Work Order ID 92003

Item Name: Skid Deflector Assembly

APICAL INDUSTRIES, INC.	ENGINEERING CHANGE NOTICE NO. 02937		SHEET 1 OF 1	
	DWG NO. 647.1700	REV: NC	PREPARED BY J. JACKSON	DATE: 07/14/10
	EFFECT ON DWG <input type="checkbox"/> INC. <input checked="" type="checkbox"/> UNINC.			
DWG TITLE: SKID DEFLECTOR ASSY				
APPROVED BY: ENGR <i>[Signature]</i>		MFG <i>[Signature]</i>	QC <i>[Signature]</i>	EFF: CURRENT ORDER
TRANSACTION CODES (TC): A-ADD C-CREATE R-REVISE D-DELETE		REASON: REVISED F/N 8 AND NOTE <u>3</u> . ADDED INSPECTION DIMENSIONS TO DRAWING VIEWS.

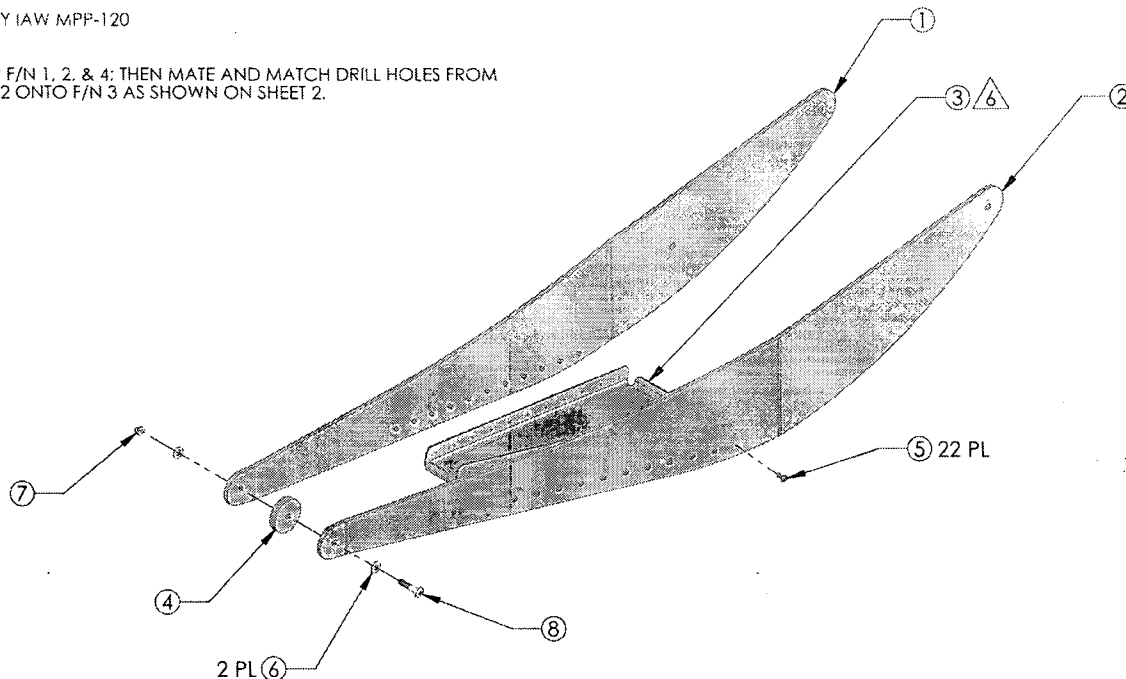
3 FINISH: HARD ANODIZE IAW MIL-A-8625 TYPE II CLASS 2, COLOR BLACK;
PRETREAT PRC-DESOTO PR-148 ADHESION PROMOTER, COLOR BLUE;
PRIME IAW MIL-P-23377J TYPE I CLASS N

8	IR	601.1622	1	SCREW	MS27039-1-14 /
F/N	TC	PART NUMBER	QTY	DESCRIPTION	MATERIAL/SPECIFICATION
DOCUMENTS EFFECTED:					DER REVIEW REQUIRED
<input type="checkbox"/> MDL <input type="checkbox"/> INSTALL INSTRUC <input type="checkbox"/> FMS <input type="checkbox"/> ICA <input checked="" type="checkbox"/> BOM					<input type="checkbox"/> MAJOR <input checked="" type="checkbox"/> MINOR
